Stantec Consulting Services Inc.
65 Network Drive, 2nd Floor, Burlington, MA 01803

March 3, 2021
File: MassDOT Project No. 606635 / 109597

**Reference: Request for Amendment to Order of Conditions (MassDEP File No. 239-815)
Reconstruction of Needham Street and Winchester Street, Newton Massachusetts**

FIGURE 3 - MITIGATION PLAN

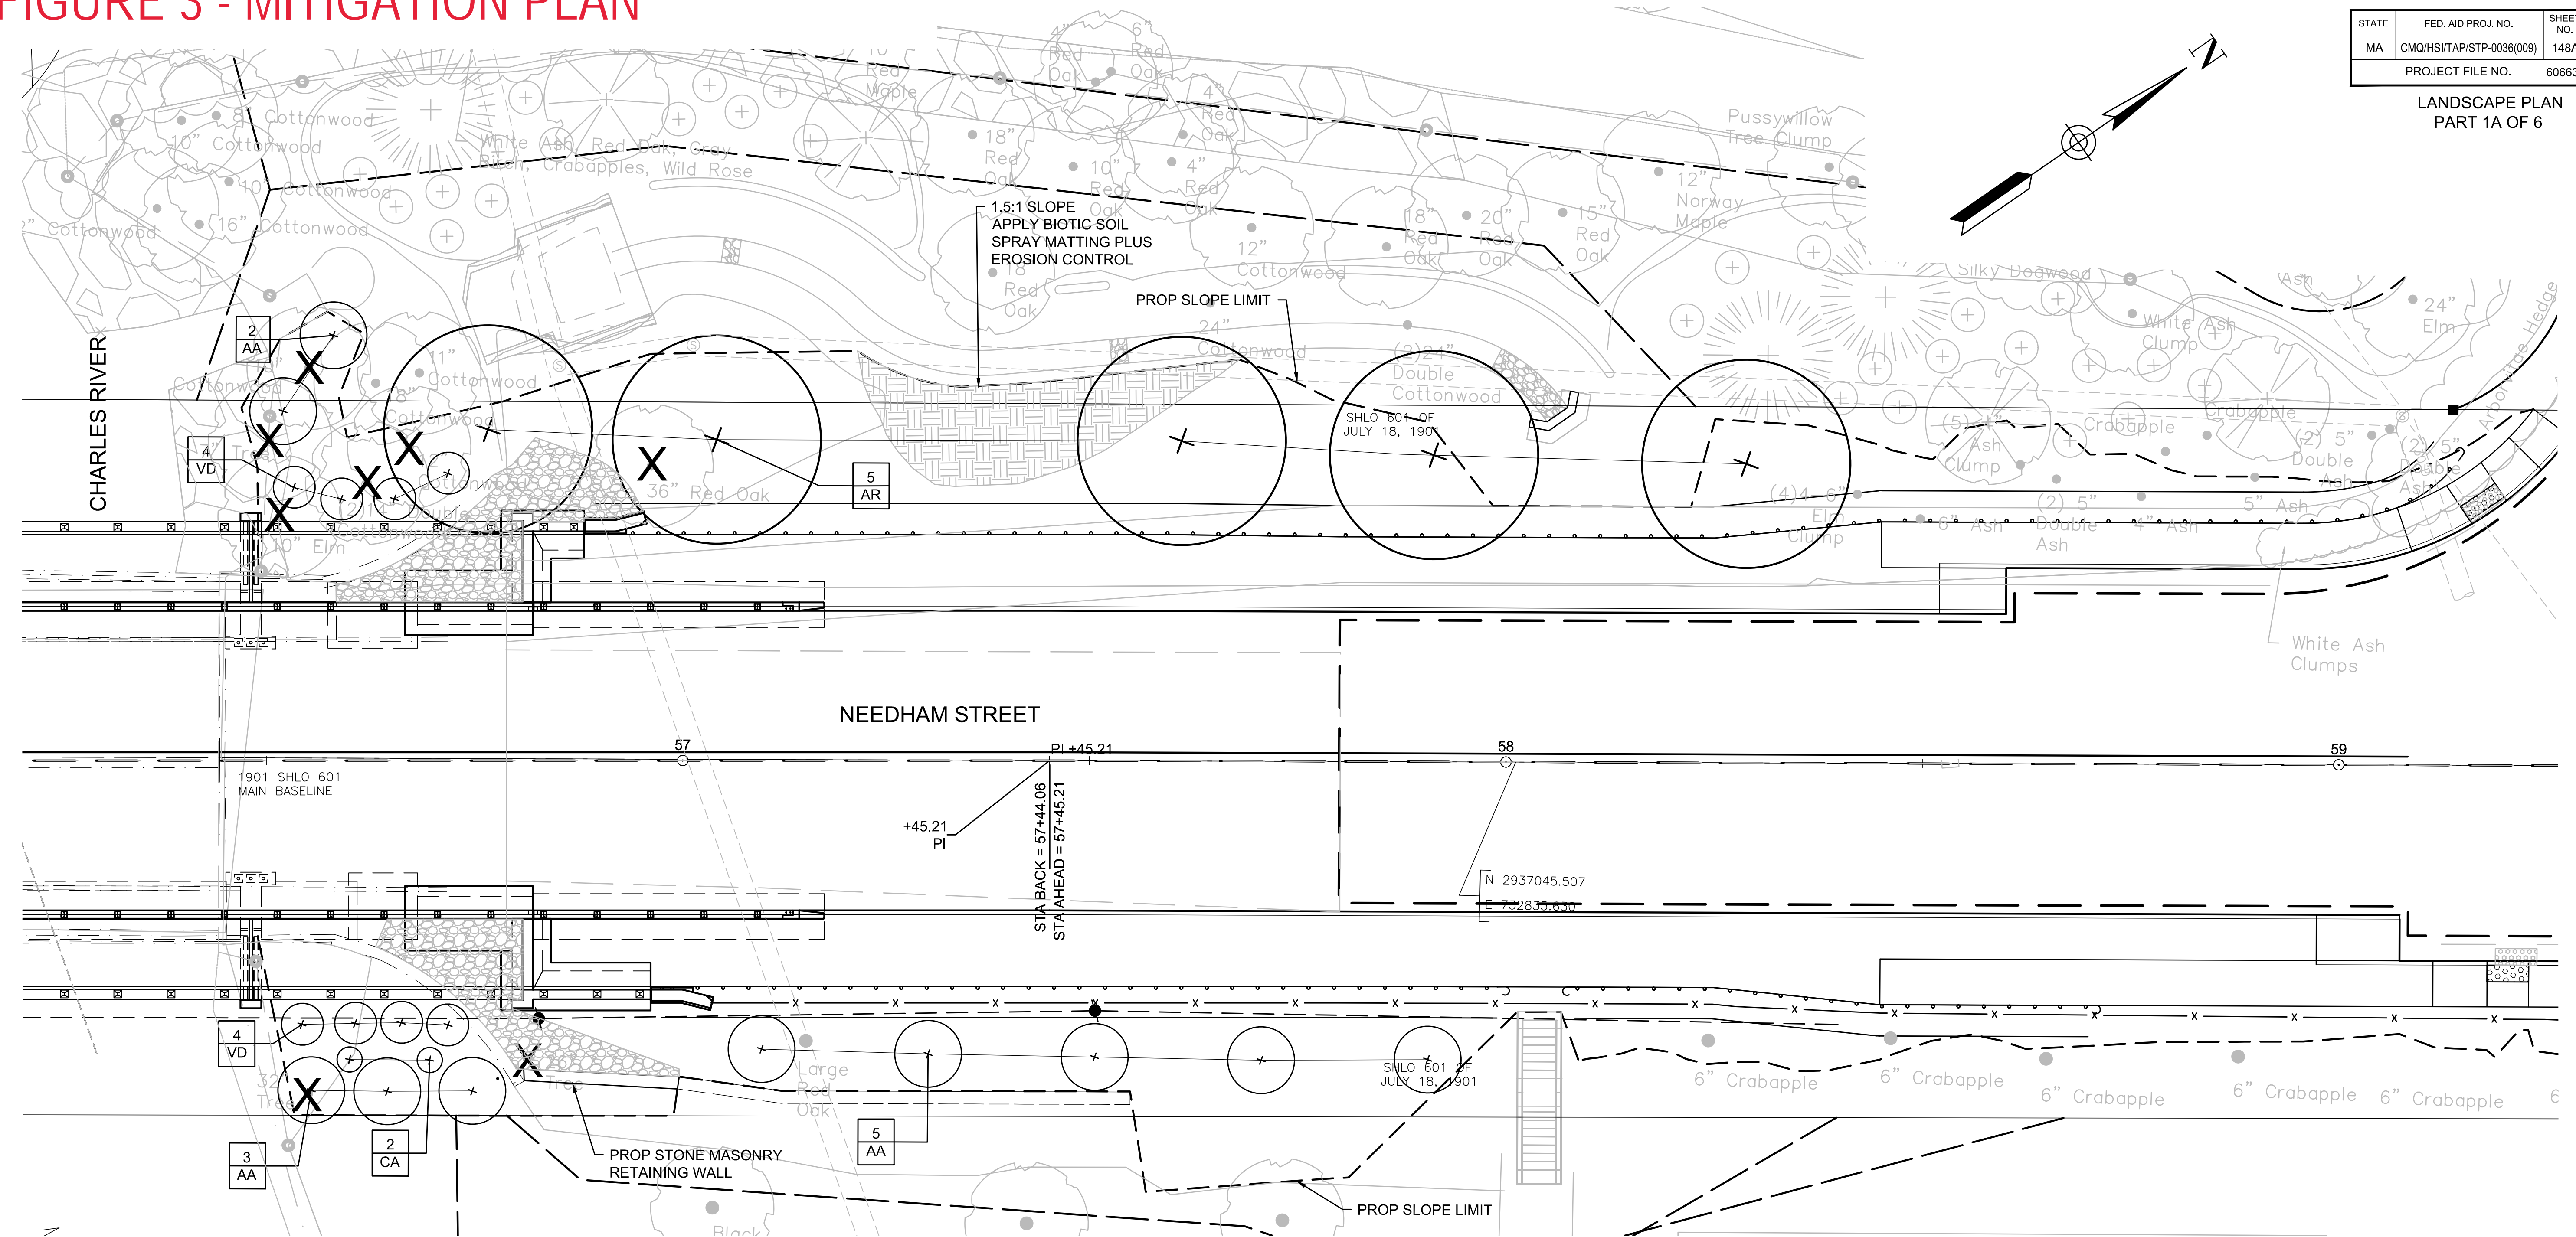
1. *Vegetation Removal and Planting-* A temporary utility pole is required on the NW quadrant of the bridge to temporarily relocate the overhead wires to be a minimum of 10 feet away from construction equipment and material required to construct the cantilevered sidewalk on both sides of the bridge as well as to maintain continuity of electrical power services during construction. A clear path of 10 feet is needed for Contractor crews and equipment to access the stone arches on the underside of the bridge for both the NW and NE quadrants of the bridge. On the NE quadrant, installation of the temporary utility pole will require cutting and stumping of two mature trees (26" and 32" in diameter at breast height) and the clearing of other vegetation located within the footprint. On the NW quadrant, contractor access for a crane required for the installation of the cantilevered sidewalk will require cutting and stumping of two 10" diameter trees and the clearing of other vegetation located within the footprint (including a twin 14" tree that has fallen). There is an existing 36" diameter Oak tree located on the NW side slope that is in conflict with the construction of the proposed concrete end post for the bridge as well as in a 1.5-foot fill area and will need to be removed.

To mitigate the loss of vegetation, MassDOT is proposing to replace the trees with woody vegetation at a 3:1 ratio. Trees that will interfere with the cantilevered sidewalk system when at full height are not practical or desirable and will be avoided in this location and shrubs will be planted. We coordinated with Mark Welch on the species and location of additional trees and shrubs and the attached a revised Landscape Plan reflects his valuable input. This work is to take place in BLSF, Riverfront Area and the 100-foot buffer zone. See Figures 1 – 5.

Trees that are required to be removed will be replaced at a 3:1 ratio with woody vegetation in the same vicinity. New plantings will be of native species that are already included in the base contract, where possible. Large shrubs (growth height 10-15 feet) are proposed in the vicinity of the cantilevered sidewalk to help eliminate overgrowth into the wires or onto the sidewalk. Medium trees (growth height 20-25 feet) are proposed near the bridge and on the side slope on the eastern side where the overhead wires will be located. See Figure 3.

FIGURE 4 - SEDIMENTATION CONTROL

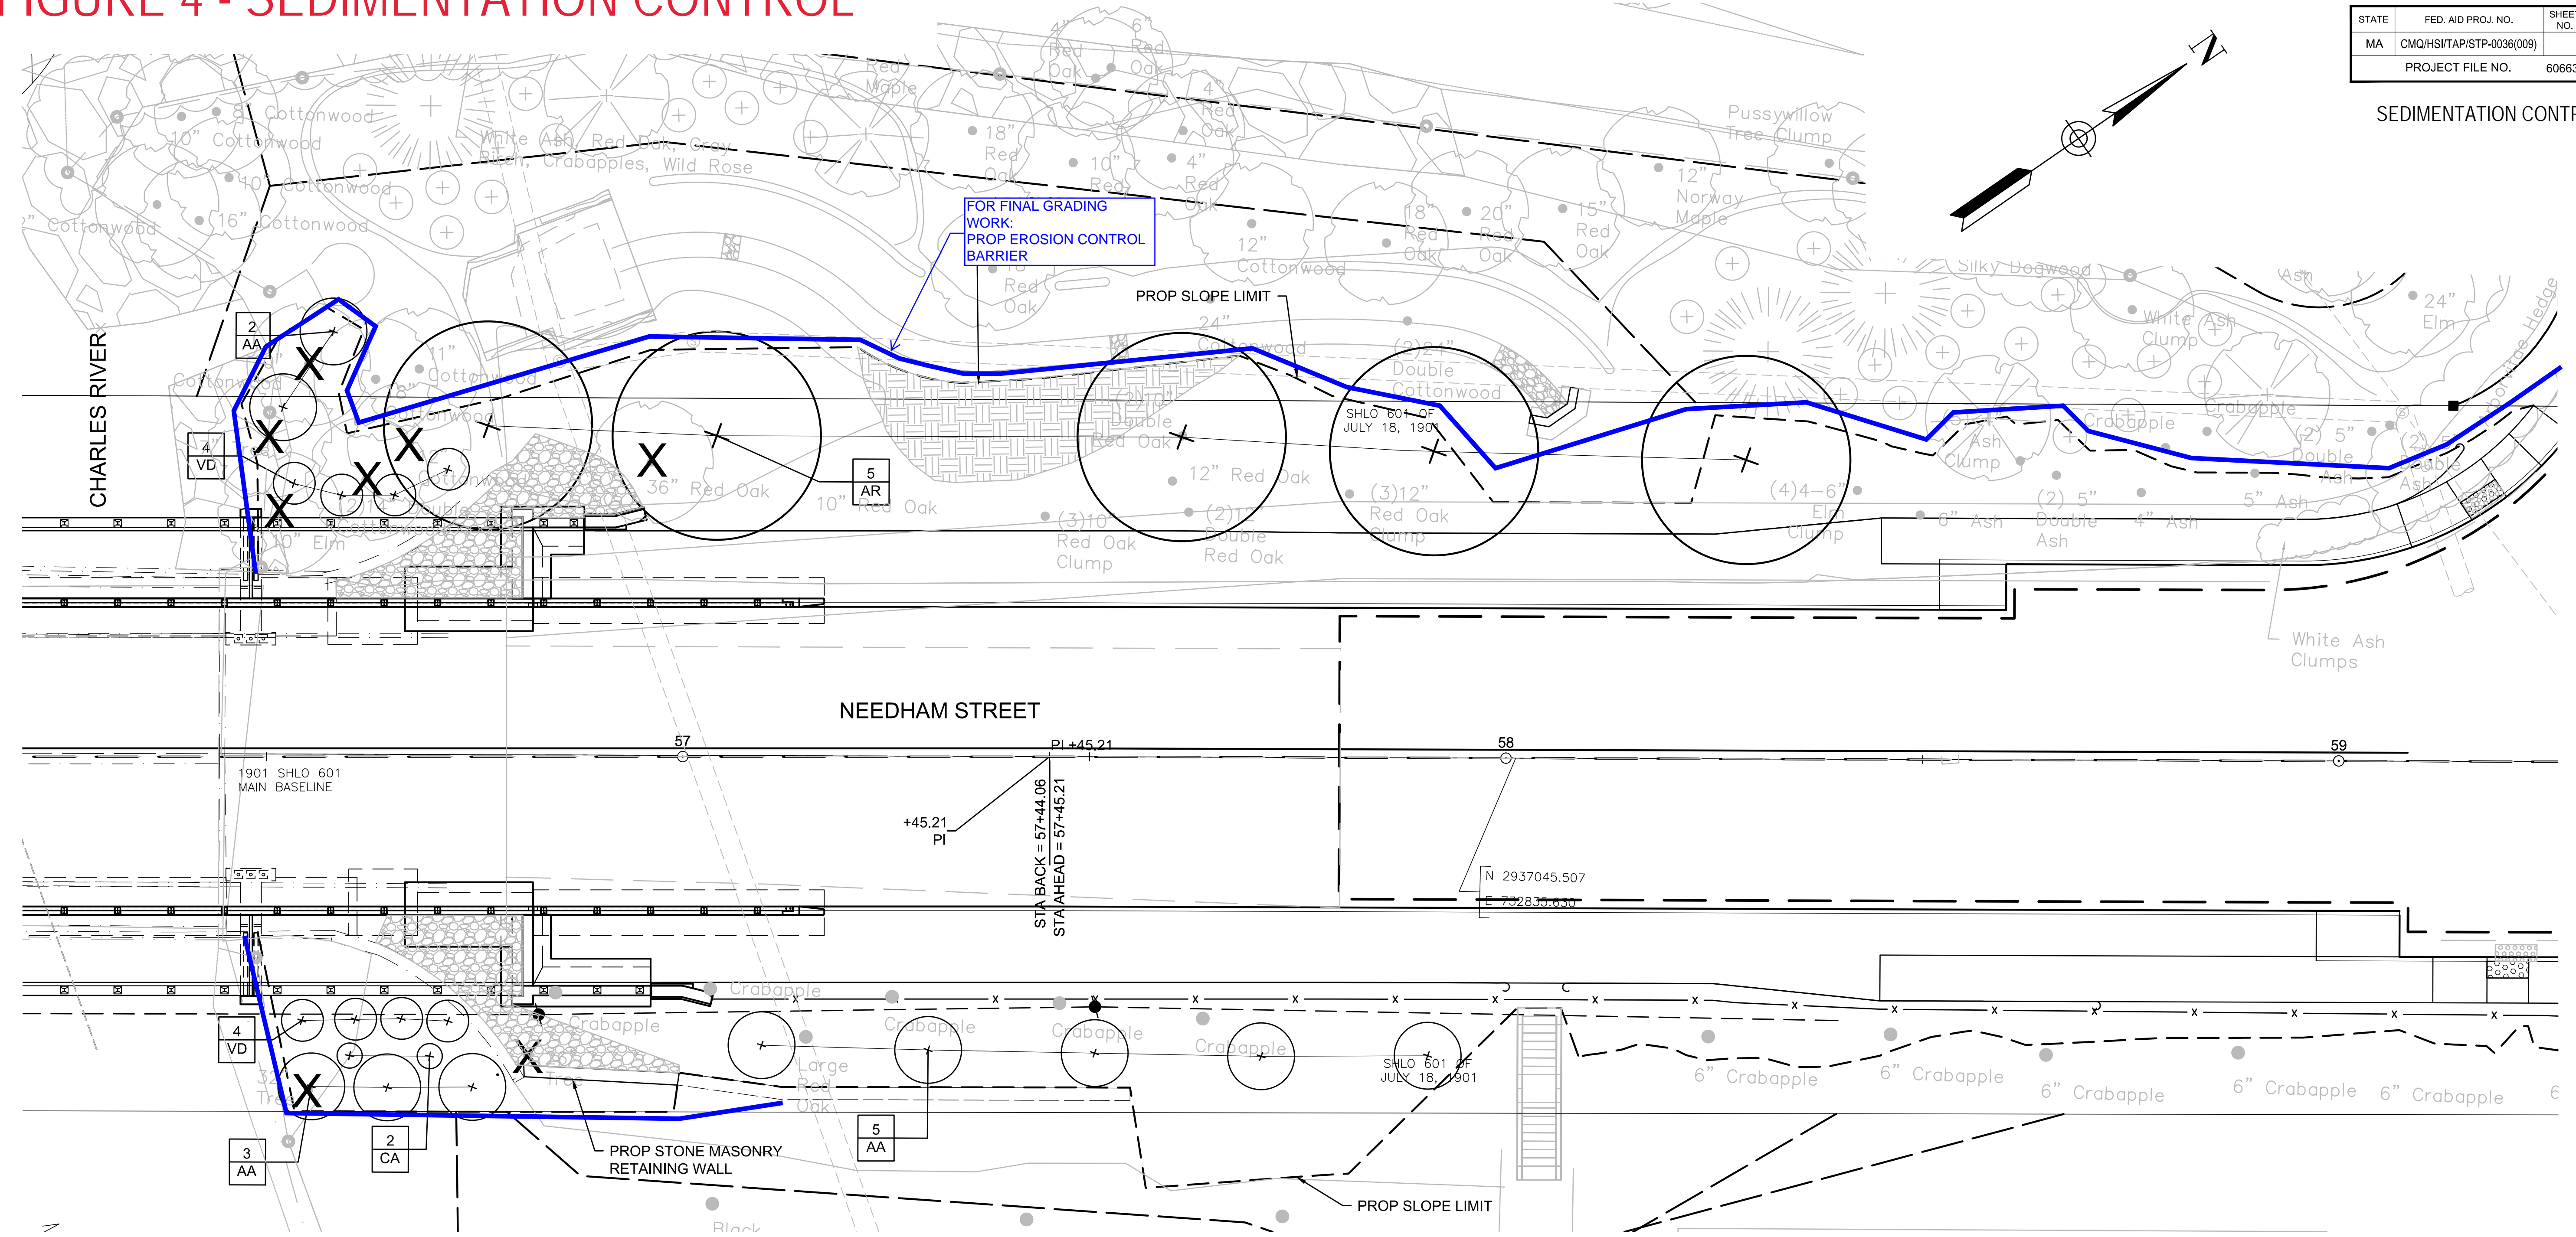
5. *Roadway/Swale Slope Stabilization*- The swale located on the NW quadrant of the project conducts stormwater from the project site and is designed to meet the need to effectively convey water, so the channel design remains as originally proposed with rockfill. However, based on comments from Jennifer Steel, an option is to apply a native seed mix to the 1:5:1 slope immediately upgradient of the swale and to then use a spray matting consisting of mechanically bonded fiber matrix that is 100% biodegradable for permanent slope stabilization as the seeded vegetation becomes established. This will provide enhanced wildlife habitat benefits as the area will be vegetated with wildflower mix and provide pervious ground for additional stormwater infiltration. Trees will be planted in the 2:1 slope, just upgradient of the steeper portion above the swale as part of the overall site mitigation. All toe of slope sedimentation controls that are in place during construction will remain in place until the slopes are stabilized and have at least 75% vegetative coverage. See Figure 5.

FIGURE 6
CONSTRUCTION STAGING FOR TEMP SUPPORTS AND ARCH RE-POINTING - CENTER SPAN

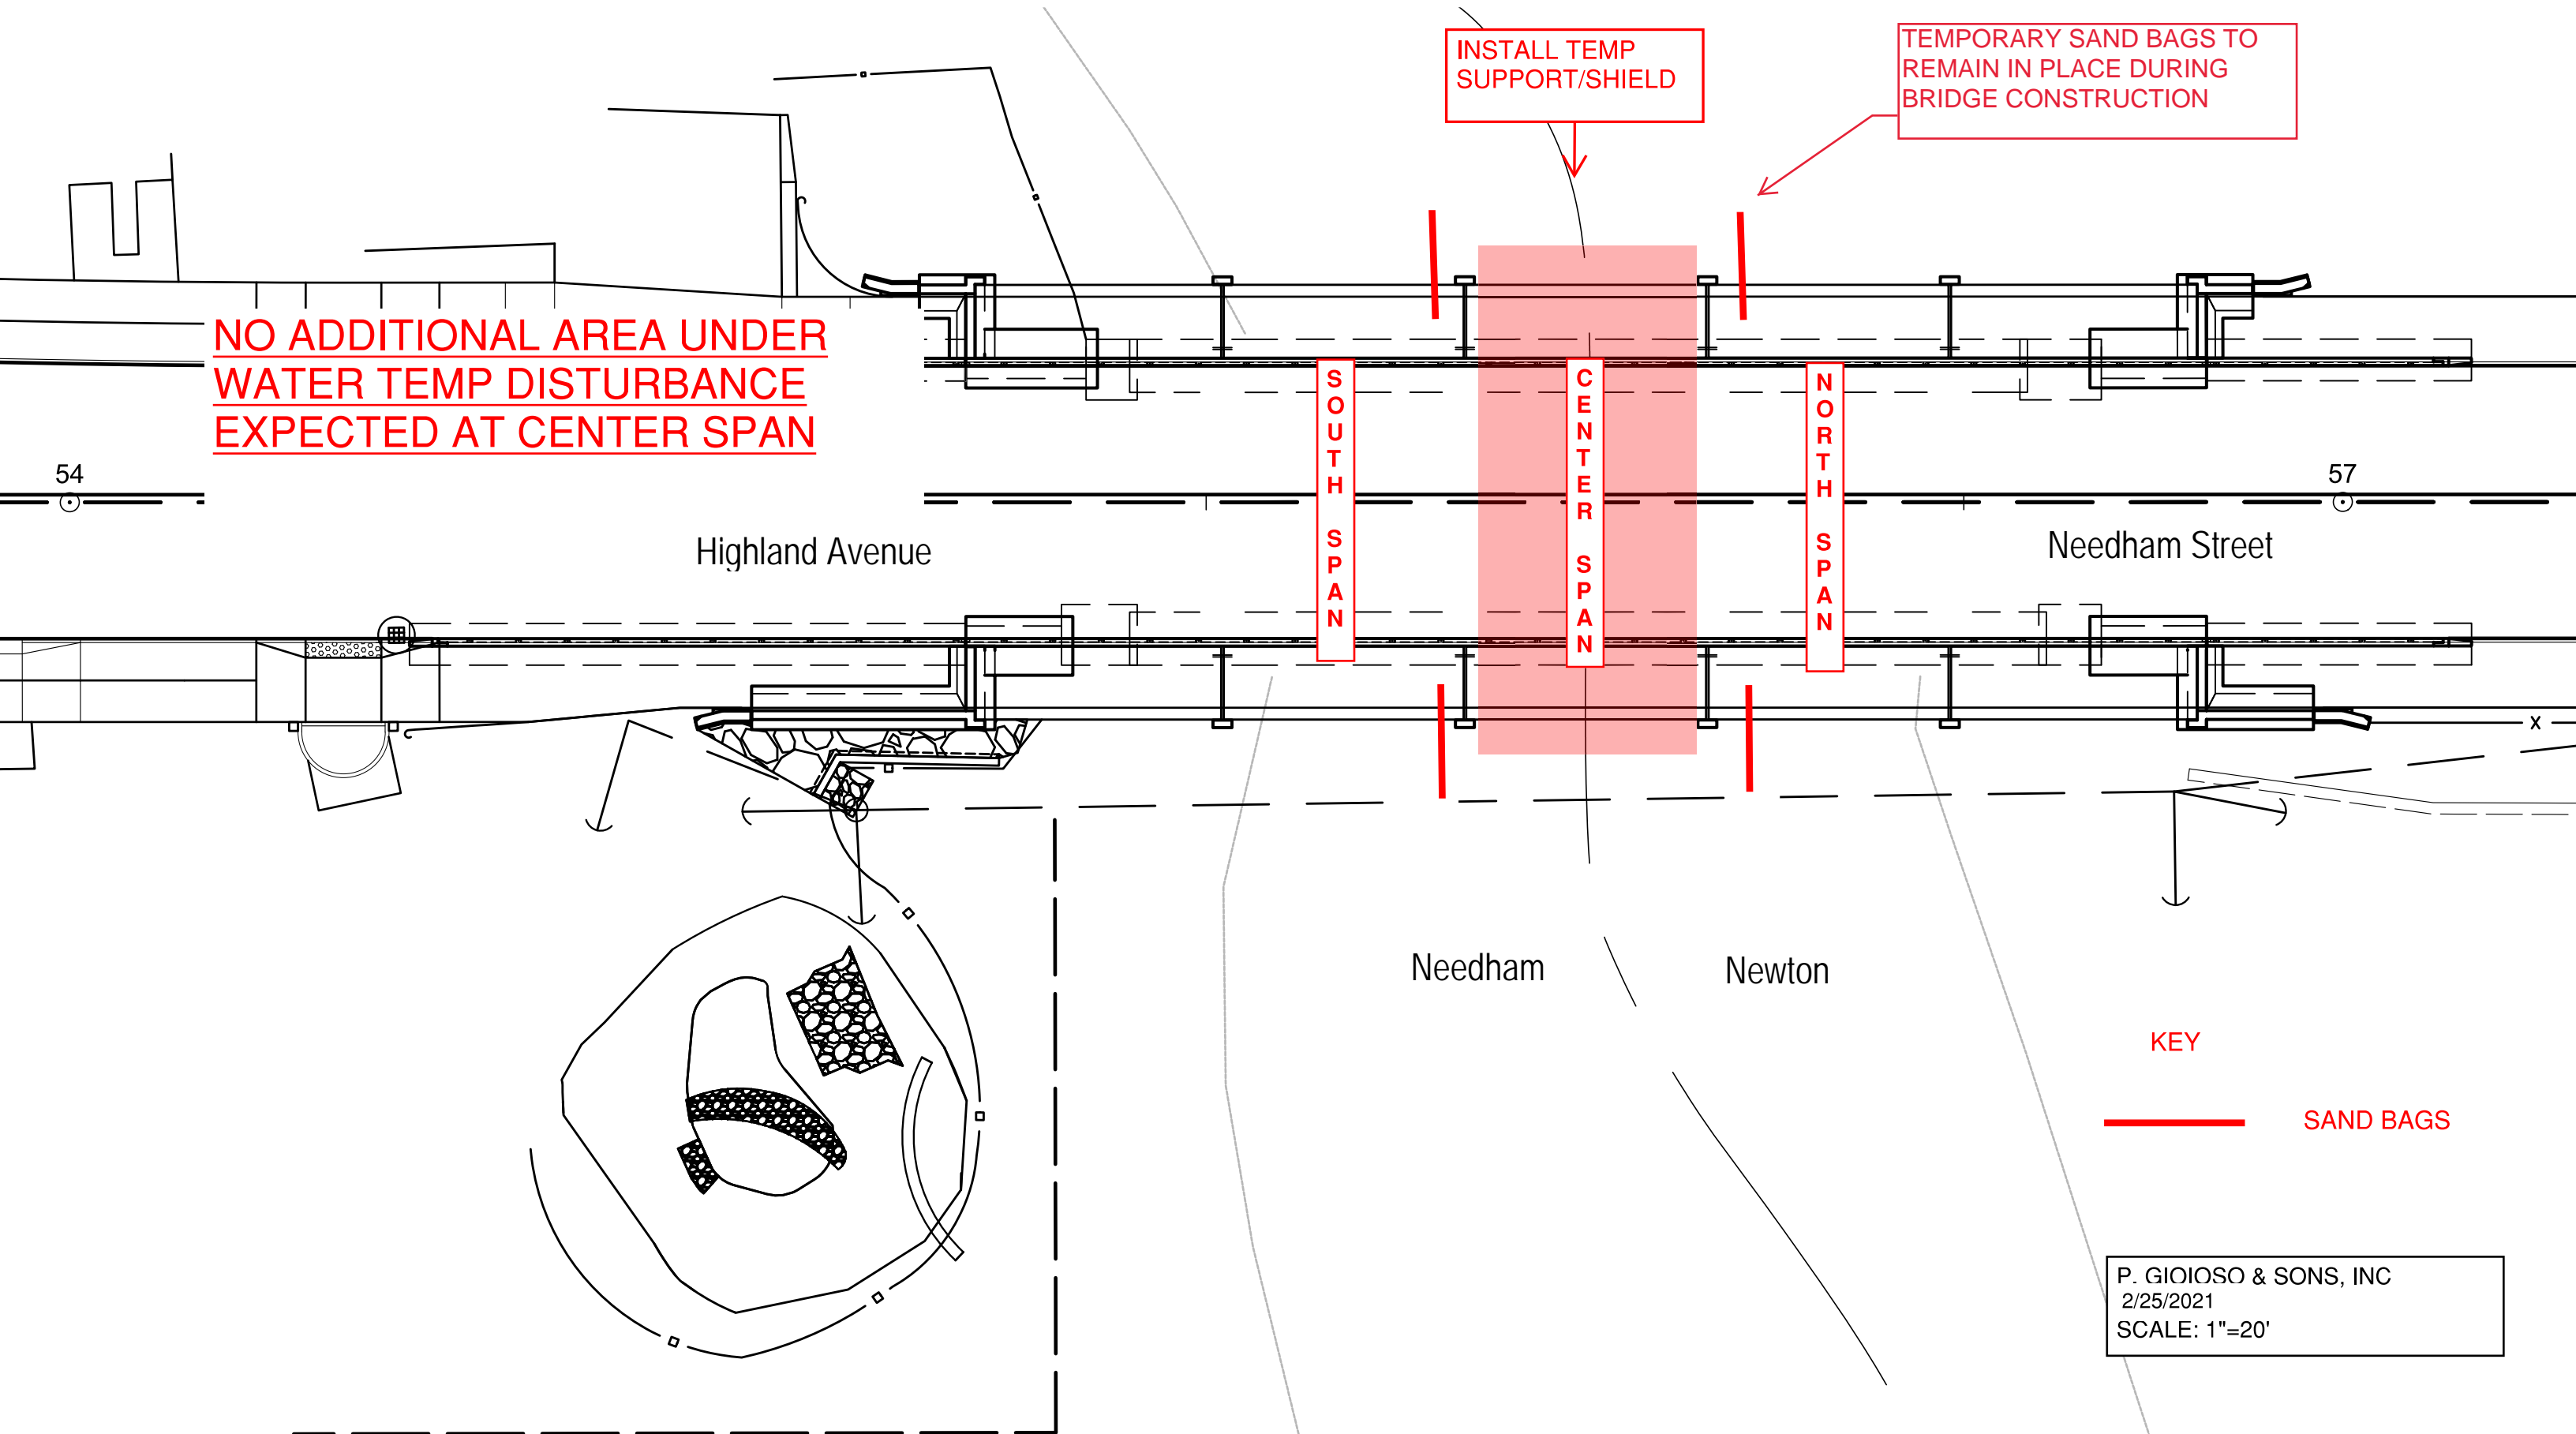
Construction staging within the river is necessary to support this effort. For the northern span, a 3,000 SF area will need to be established in LUWW to install a temporary support shield. Existing rocks and debris will be removed from under the arch and the area dewatered to place concrete footings to support the construction. Sandbags will be set up at the perimeter of the dewatering area and used for dewatering control. See Figures 6-9.

A turbidity curtain will be used on the downstream side of the northern arch. For the center span, a concept design being considered for the temporary support in the center span uses floating wooden rafts (8'x15') and a power boat for installation and demolition of the temporary supports. It is likely the navigable way will be closed to users during the installation and demolition. This work is to take place in BLSF and LUWW. See Figures 8 and 10.
